Grant Road Urban Overlay Document Preliminary Draft – January 25, 2018

January 25, 2018 Draft

Grant Road Investment District Urban Overlay Document

Figure C-2-GIIS-2: Allowed building heights

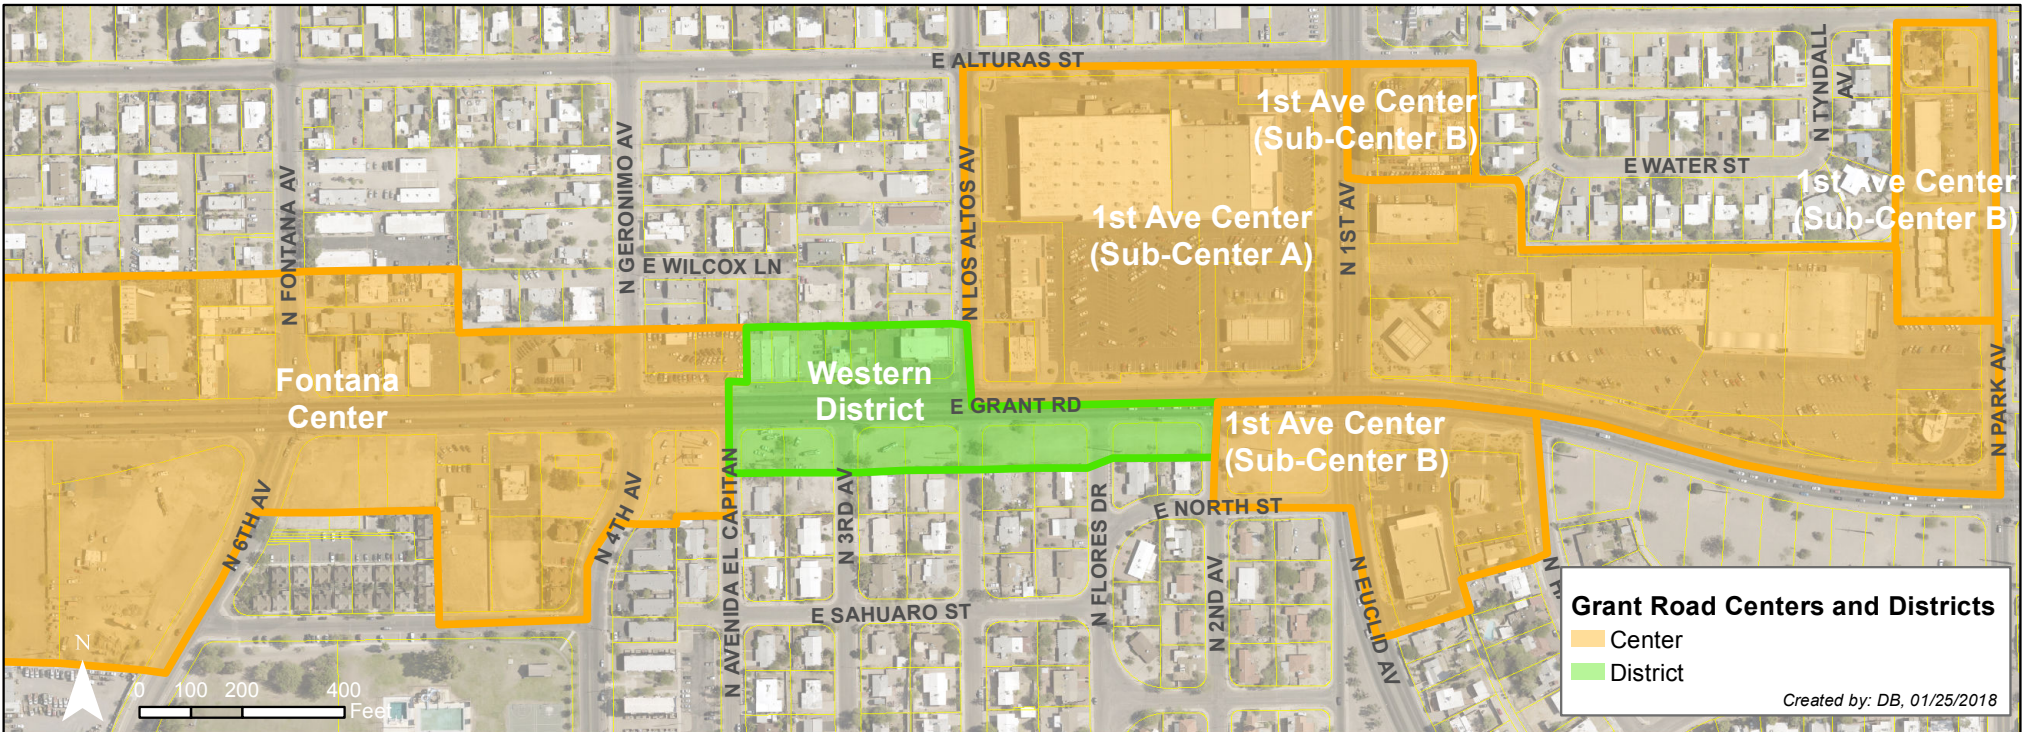
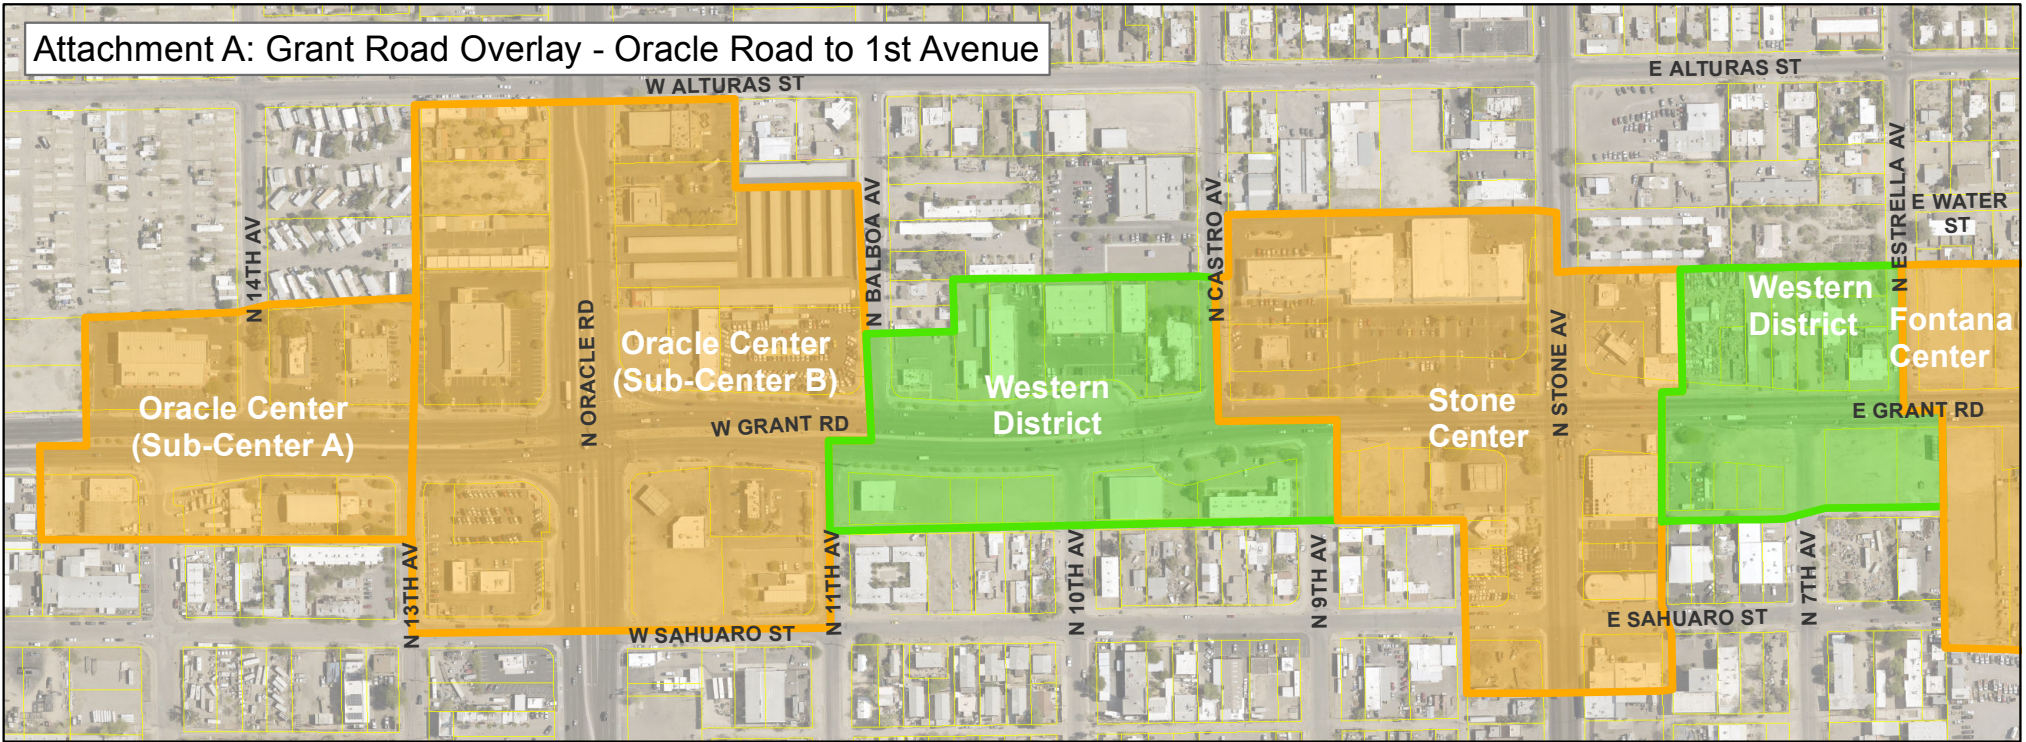
Comment [DB15]: Should we revise maps to include the following concept?:
 UOD Center - Major - 75 feet
 UOD Center - Minor - 60 feet
 UOD Segment - 40 feet
